**RFT# 4234 - Addendum #1
Window & Cladding Replacement
Dutch Settlement Elementary**

To: All Bidders
Date: May 21, 2024
From: Nancy Rideout, Purchasing Manager
Office: (902) 464-2000 ext. 2222
Email: nrideout@hrce.ca

The bid documents shall be amended, and new drawings and clauses added, and shall become part of the contract documents as follows:

1 FLOOR PLAN - ELECTRICAL
 E-101 SCALE: 1/8" = 1' 0"

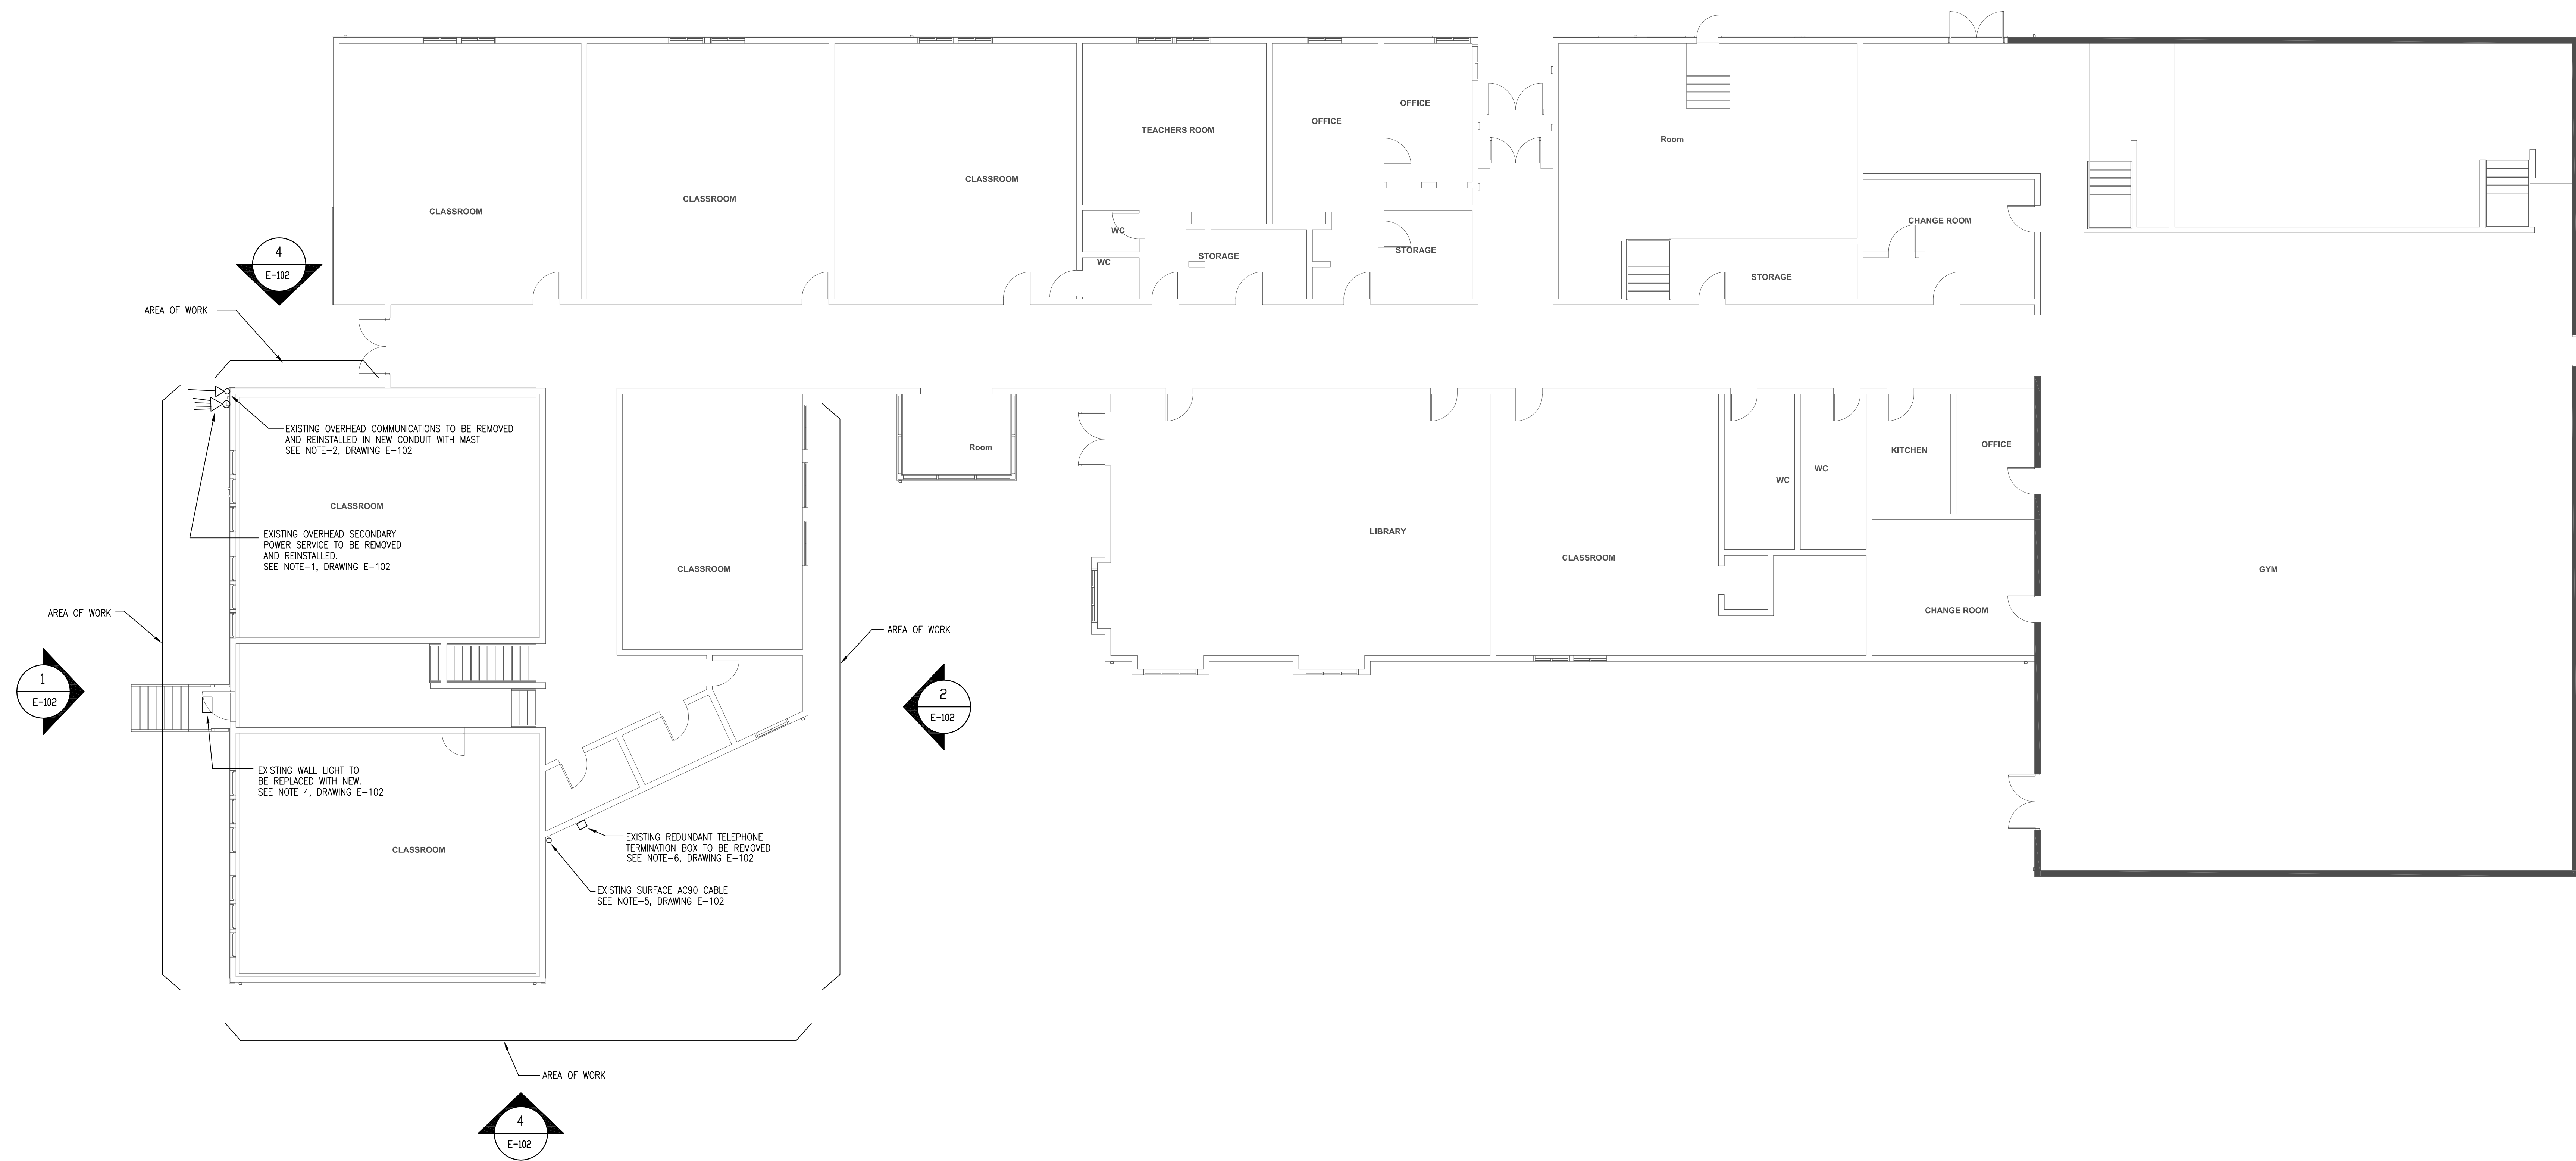
- a. E-101 – Floor Plan Electrical
- b. E-102 – Electrical Elevations and Specification

1 SOUTH ELEVATION - ELECTRICAL
SCALE 1/8"=1'-0"

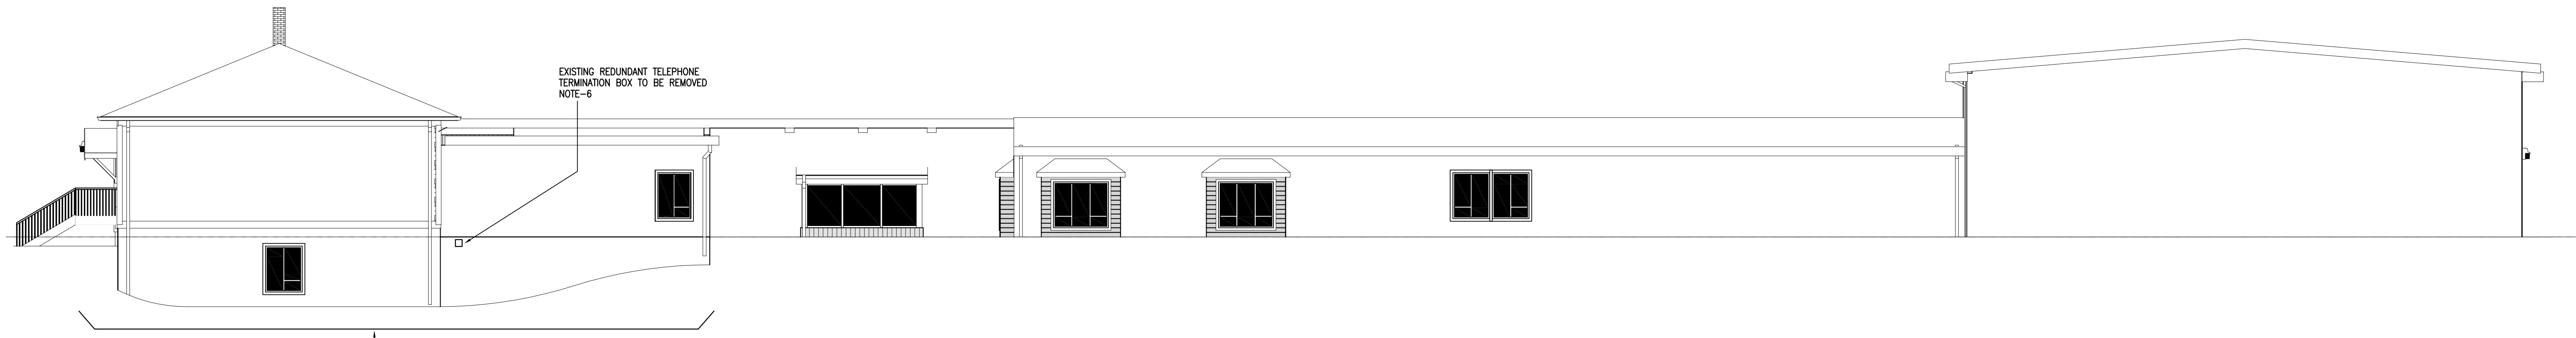
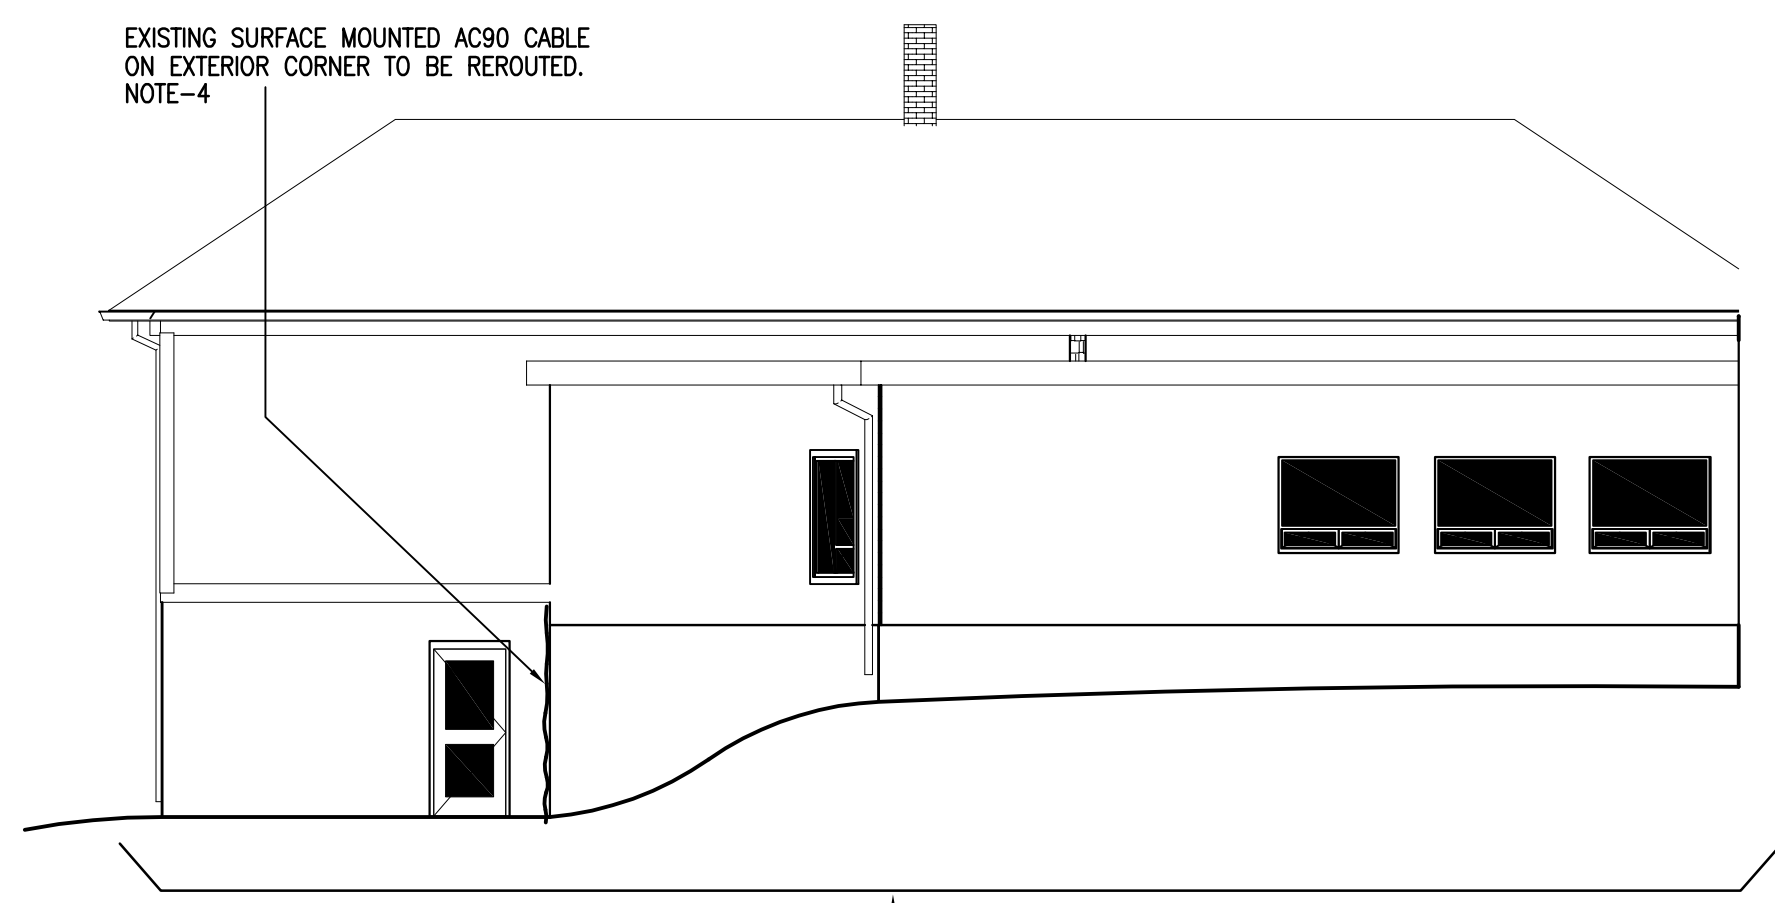
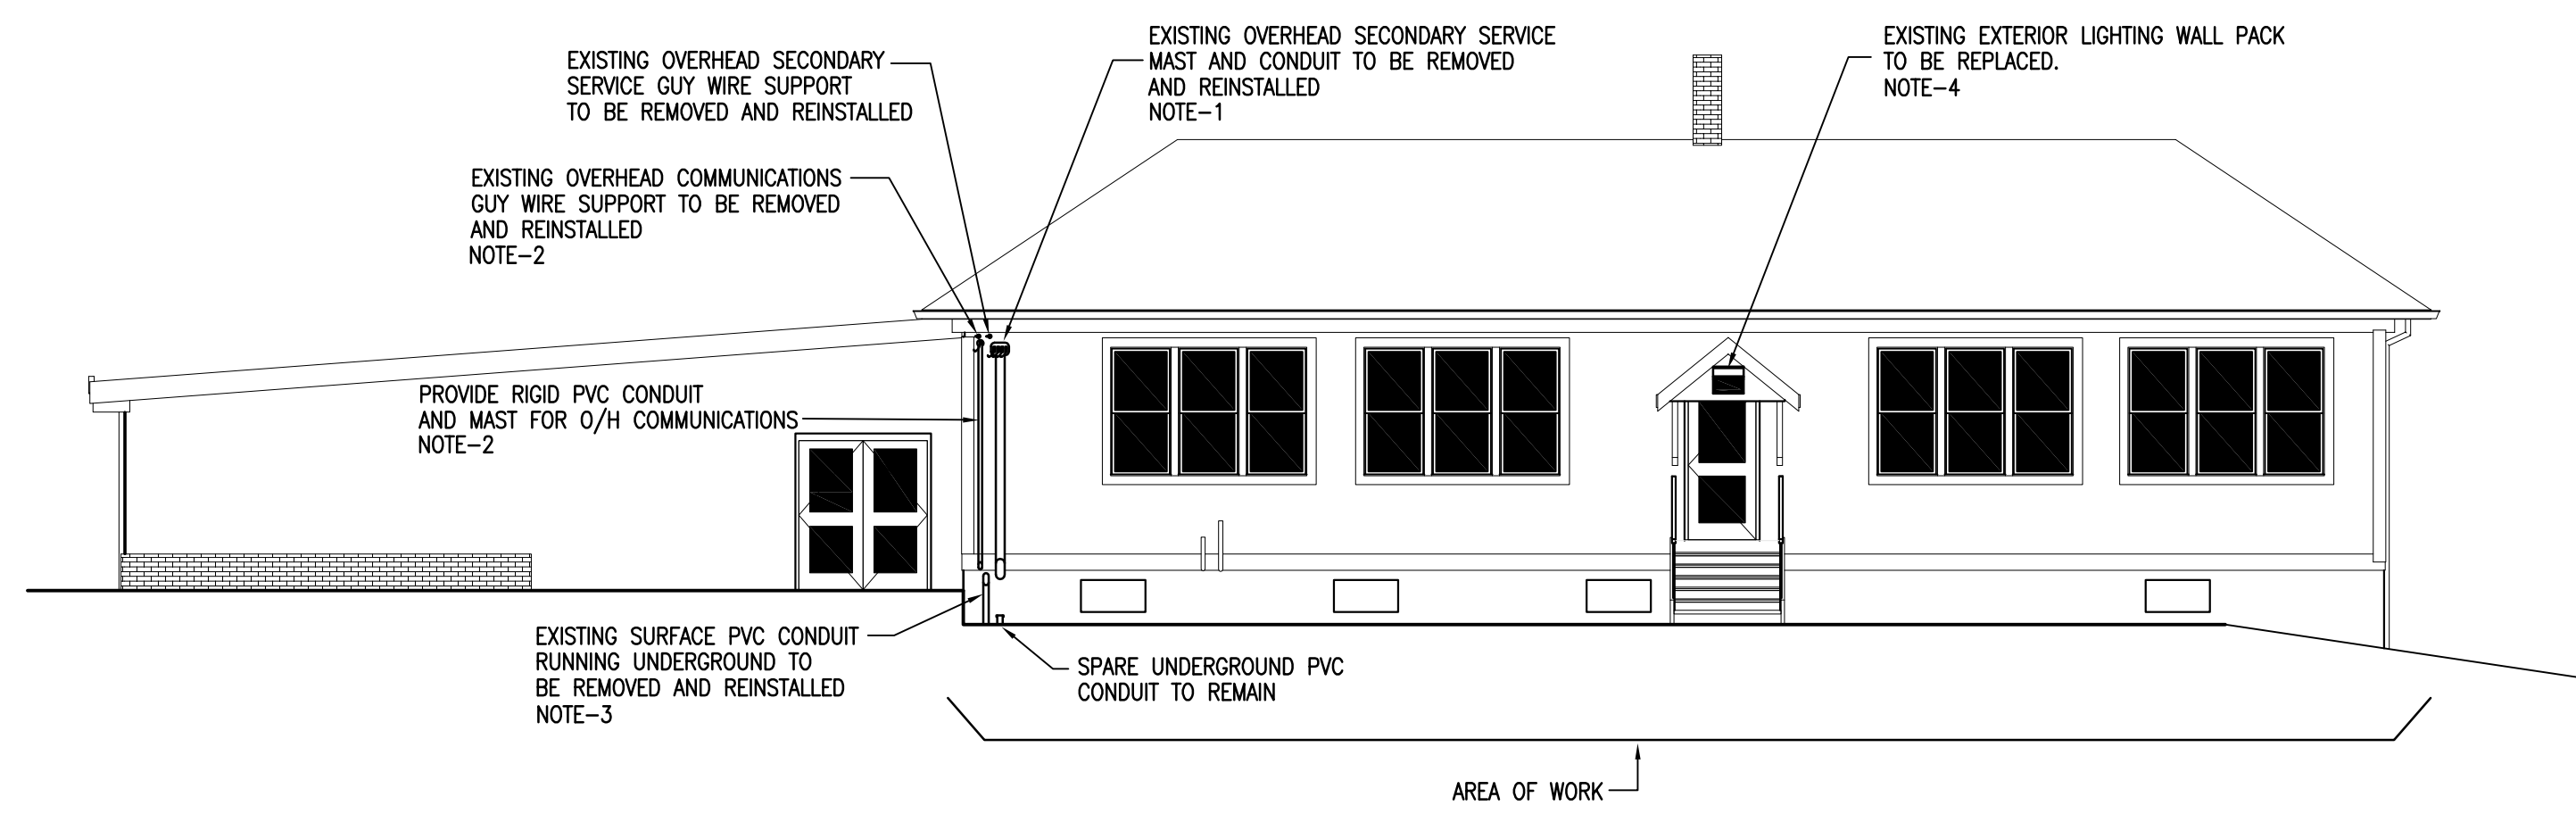
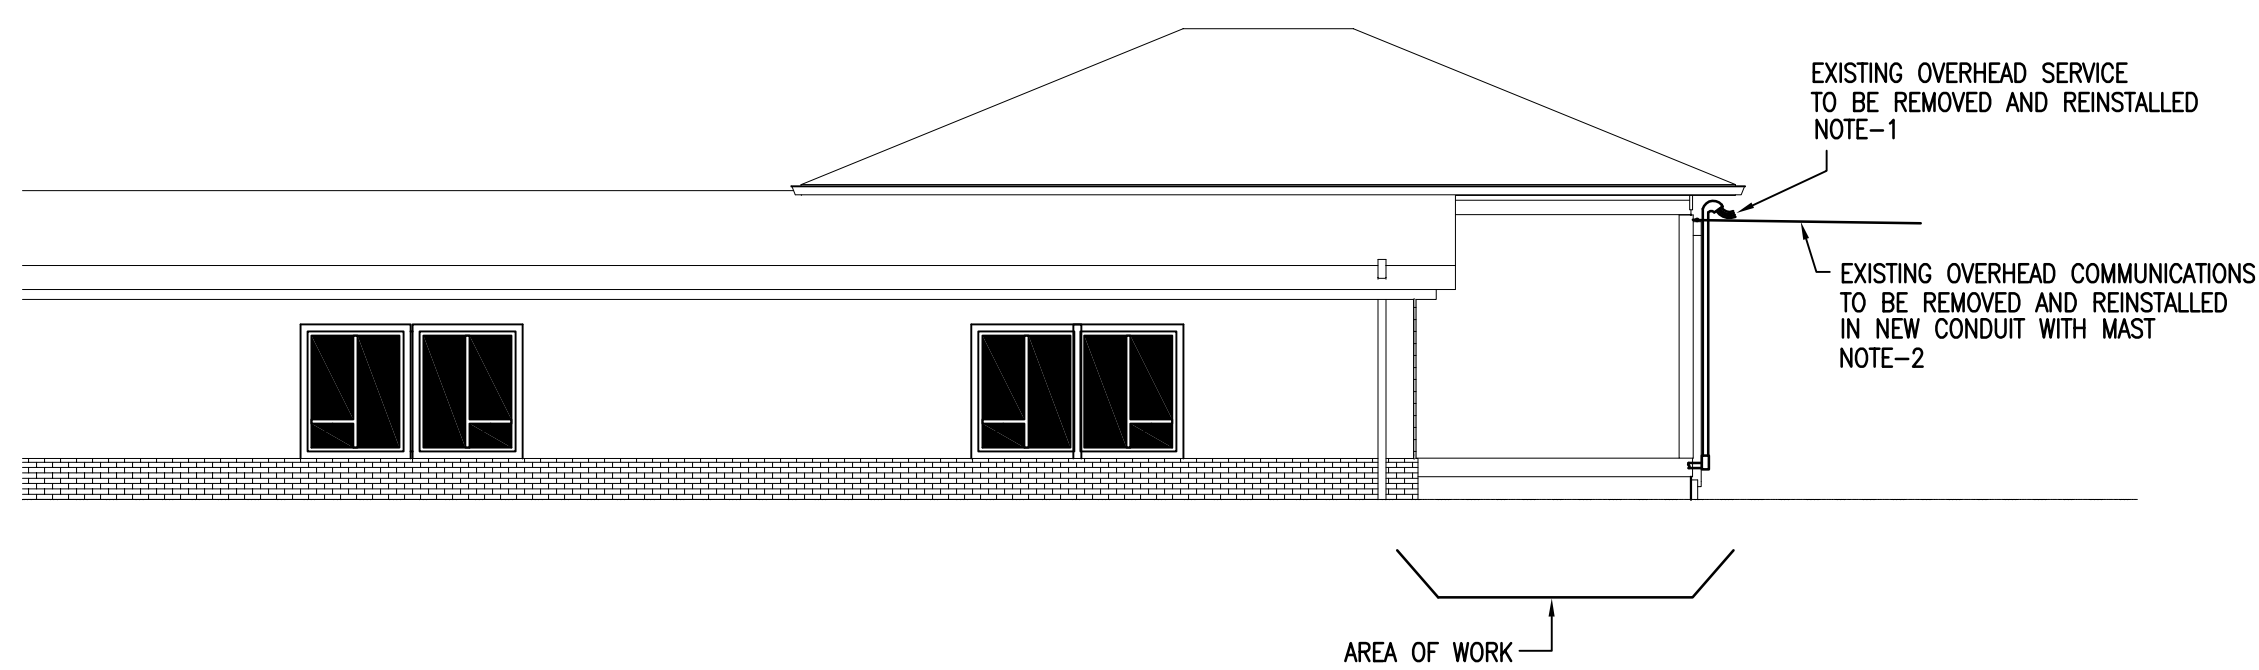
NOTE-1:
EXISTING OVERHEAD SECONDARY SERVICE MAST AND CONDUIT TO BE TEMPORARILY REMOVED, REINSTALLED AND RECONNECTED AS REQUIRED TO ACCOMMODATE INSTALLATION OF NEW WALL CLADDING. ELECTRICAL CONTRACTOR SHALL LIASE WITH NSP AS REQUIRED AND COORDINATE ANY POWER SHUTDOWNS. ANY NSP COSTS ASSOCIATED WITH REMOVALS SHALL BE BY OWNER.

NOTE-2:
EXISTING OVERHEAD COMMUNICATIONS SERVICE SHALL BE DISCONNECTED, REMOVED, REINSTALLED IN NEW RIGID PVC CONDUIT C/W MAST AND RECONNECTED. ELECTRICAL CONTRACTOR TO LIASE WITH SERVICE PROVIDERS AS REQUIRED AND COORDINATE ANY SYSTEMS INTERRUPTIONS. ANY SERVICE PROVIDERS COSTS ASSOCIATED WITH REMOVALS, OVERHEAD CABLE REPLACEMENTS, ETC SHALL BE BY OWNER.

NOTE-3:
EXISTING SURFACE MOUNTED CONDUIT TO BE TEMPORARILY REMOVED, REINSTALLED AND RECONNECTED AS REQUIRED TO ACCOMMODATE INSTALLATION OF NEW WALL CLADDING. SEAL AND MAKE WATERTIGHT.

NOTE-4:
EXISTING LIGHTING WALL FIXTURE TO BE DISCONNECTED, REMOVED, REPLACED WITH NEW FIXTURE AND RECONNECTED. EXTEND EXISTING CIRCUITRY AS REQUIRED. MANUFACTURER: SIGNIFY WP60, 120VAC, 4000K C/W BUILT IN PHOTO CONTROL.

NOTE-5:
ELECTRICAL CONTRACTOR TO VERIFY IF EXISTING EXTERIOR SURFACE MOUNTED AC90 CABLE IS STILL ACTIVE. DISCONNECT AND REMOVE IF REDUNDANT. IF STILL ACTIVE, REPLACE EXPOSED CABLING, REROUTE AS REQUIRED TO MAKE CONCEALED AND RECONNECT. EXTEND CIRCUITRY AS REQUIRED.

NOTE-6:
EXISTING REDUNDANT EXTERIOR TELEPHONE TERMINATION BOX AND ASSOCIATED REDUNDANT WIRING TO BE DISCONNECTED AND REMOVED.
